Euro Jeans Ltd

Chowdhury Bari, Vogra ,Gazipur
(23.9789348N,90.3802407E)

14th May 2014

Observations

External steel stair to NW corner of Shed 2

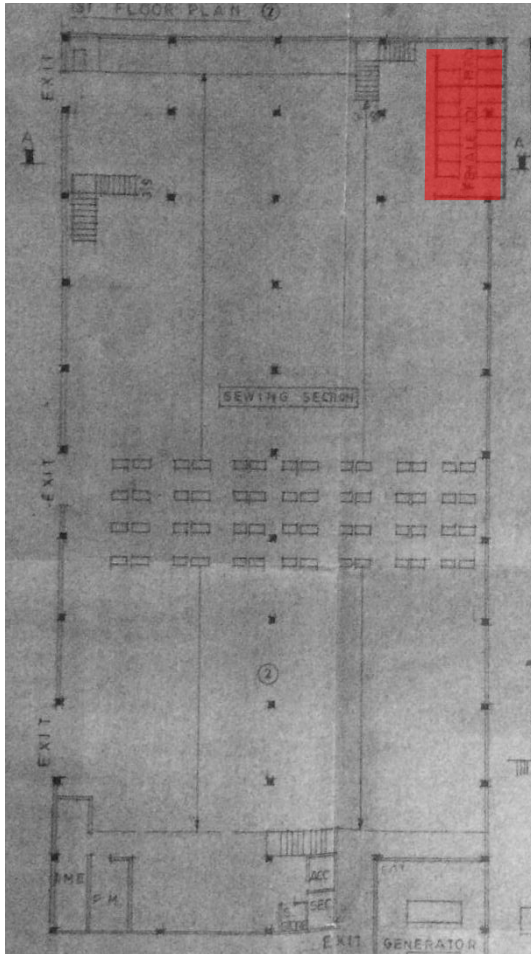
There are concerns over the structural adequacy of the external steel stair to the North-West corner of Shed 2, including atypical supports, inadequate bracing, poor connections.

Atypical supports

Poor connections

Inadequate bracing

Item No.	Observation	Recommended Action Plan	Recommended Timeline
15	Non-engineered stair to Shed 2	Building Engineer to review the design of the external steel stair to Shed 2, with special emphasis on connections and bracing, and prepare a schedule of remedial works as required.	6-weeks
16	Non-engineered stair to Shed 2	Building Engineer to implement any actions / supervise any remedial works as identified following the review	6-months
17	Water ingress from leaking services into Shed 1	Building Engineer to identify the cause of leaking and carry out any necessary remedial works.	6-weeks
18	Water ingress from leaking services into Shed 1	Building Engineer to review affected steelwork and prepare a schedule of remedial works as required.	6-weeks
19	Water ingress from leaking services into Shed 1	Building Engineer to implement any actions / supervise any remedial works as identified following the review.	6-months

Shed 1 – Ground Floor Plan

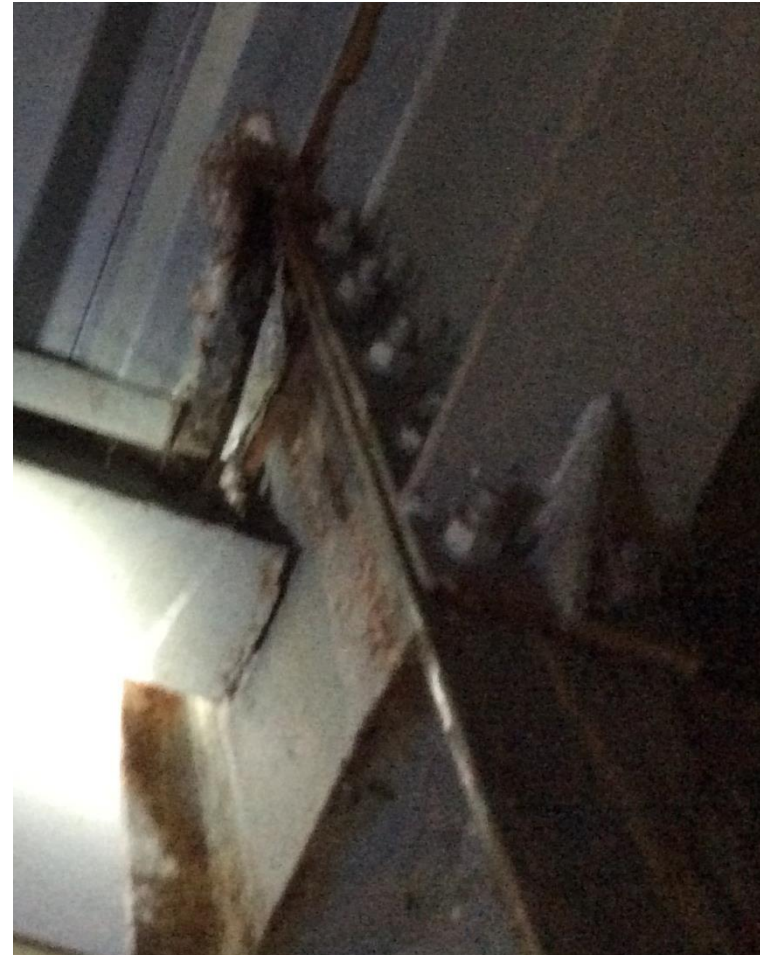
Water ingress, believed to be from leaking services, was observed in the toilet extension to the North-West corner of Shed 1, resulting in corrosion to the portal frame steelwork members and to the reinforcement steel which has become exposed in the RC slab. Remedial works are required.

Location of toilet extension to North-West corner of Shed 1. Leaking services and resulting corrosion of steelwork was observed.

Corrosion of structural steel members
